BUILDING INSPECTION
PERMIT

Permit Number: 070020

has permission to Interior and exterior renovations incl. Foundation

AT 5 SUNSET RD

SITE CALCULATIONS

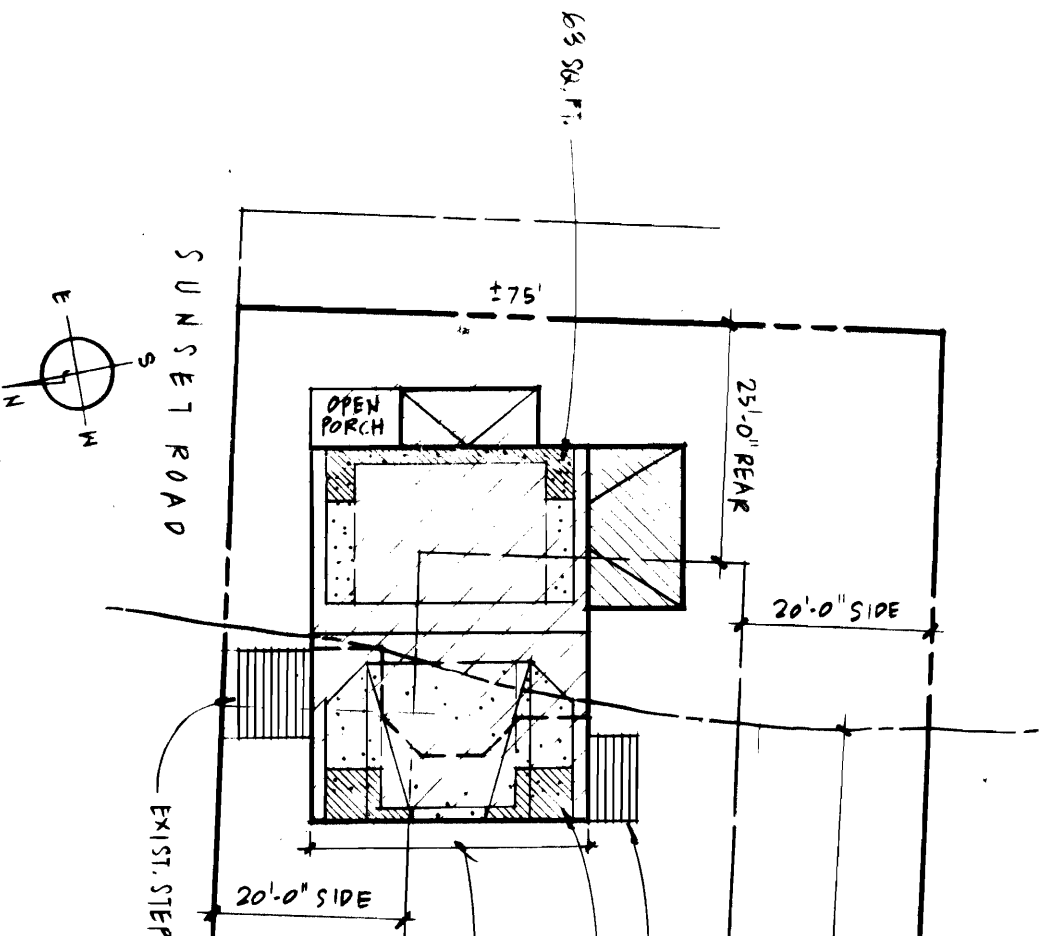
IK2
 lot size - 90,333 ϕ - 6138
 front 35' rear - 21'
 rear 35' side - 7
 side 30' by 7.5 on left.
 * needs bureau section 14-436 (a)
